FOURTH REPORT  
OF THE  
TMI-2 TECHNICAL ASSISTANCE AND ADVISORY GROUP (TAAG)

DECEMBER 1, 1982

## FOURTH REPORT OF TAAG

Figure V.B-1

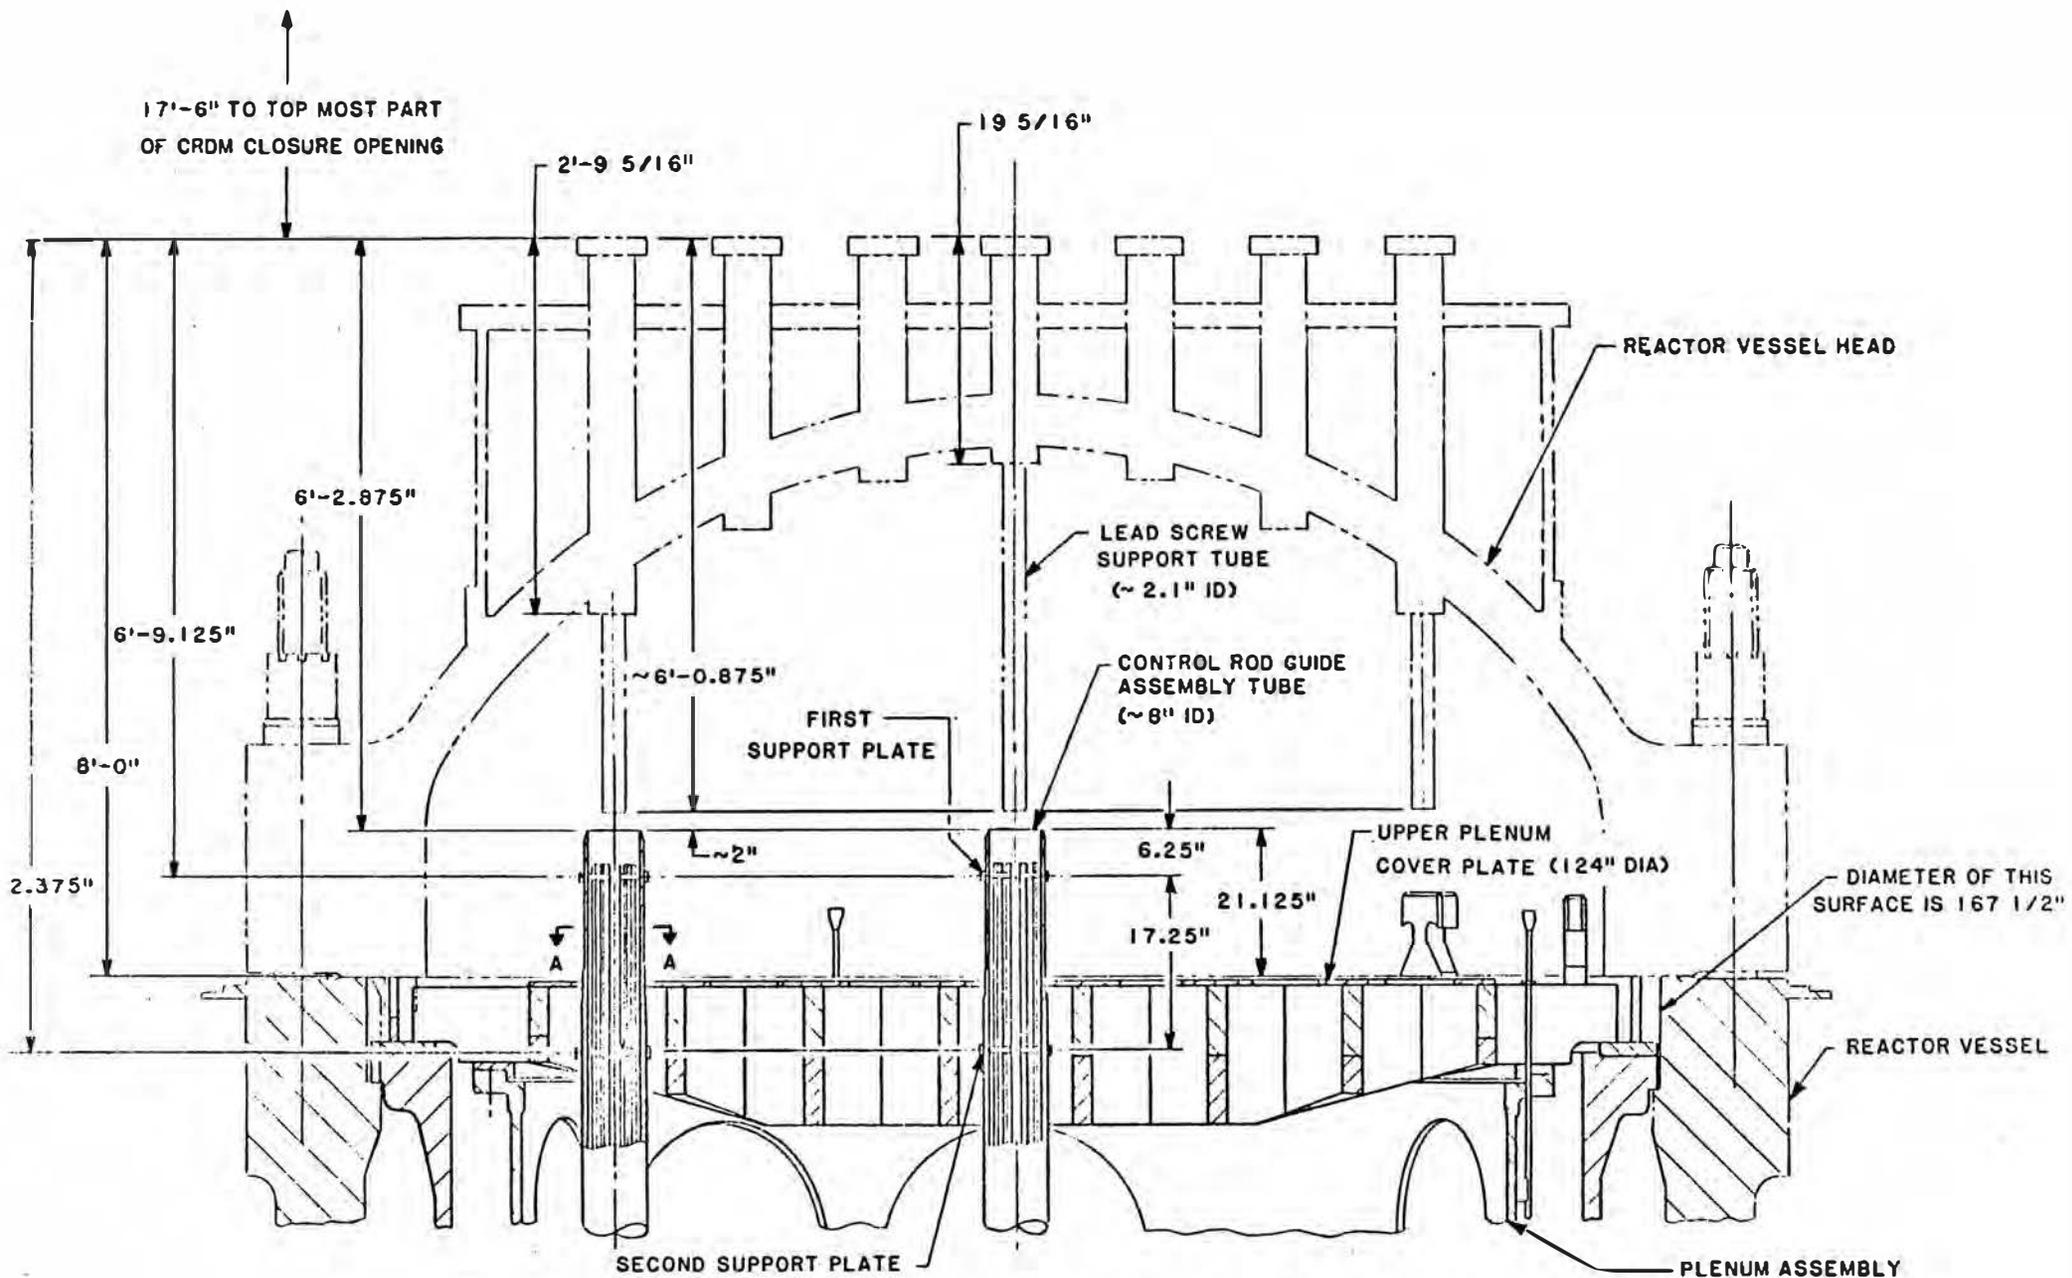
- a. TAAG recommends an under-the-head gamma scan via a leadscrew hole be performed to establish whether the gamma radiation levels during head removal will be within the levels assumed by Bechtel in planning the head removal. Even though the information available to date indicates there should be no significant fuel debris on the plenum top cover (see Section V.8.3 below), the plans assume that some fuel debris may be present on the plenum top cover. In particular, the Bechtel plan assumed a gamma radiation level of 8.5 r/hr with the head removed at a point four feet beyond the vessel inside diameter and five feet above the vessel flange surface.

- a. It is recommended that the proposed gamma scan be made underneath the reactor vessel head by inserting a radiation detector down through the CRDM's which had the leadscrews removed during the "Quick Look" examinations. Such a measurement could be performed with the vessel water level at its current elevation (e.g., about 333 ft. elevation) and with the current coolant concentration of Cs-137, i.e., about 3  $\mu$ Ci/ml. Based on the preliminary dose estimates summarized in Table V.B-1 such measurements should provide clear evidence of whether the gamma source on the plenum top cover is equal to or less than that assumed by Bechtel for head removal planning purposes. Preliminary calculation indicates that the dose rate limit, at an elevation near the top cover of the plenum and underneath the reactor vessel head, corresponds to about 90 r/hr (with the leadscrews in their lowered positions).

\*See Figure V-B-1 for the areas to be scanned.

Figure V.B-2

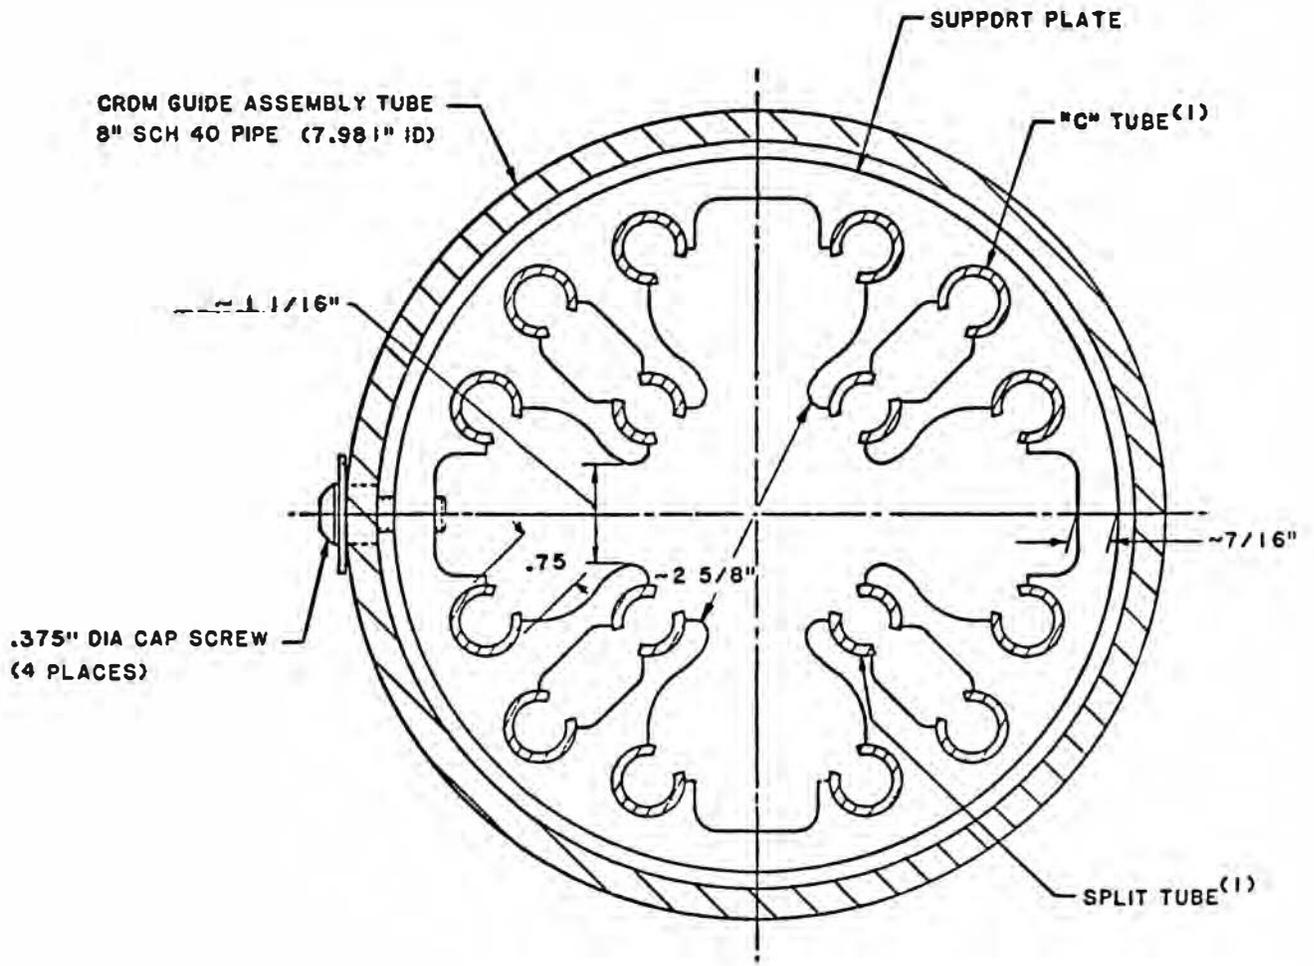
- a. In particular, the "Quick Look" video tapes show that the top surface of control rod guide assembly first and second support plates have only the light corrosion film typical of that found in normal plants. (See Figure V.B.3) This indicates that the plenum cover should also be free of debris. The "Quick Look" tapes also show the bottom surface of each support plate is not contaminated, which indicates that there is no reason to believe there is any debris on the inside surface of the reactor vessel head.
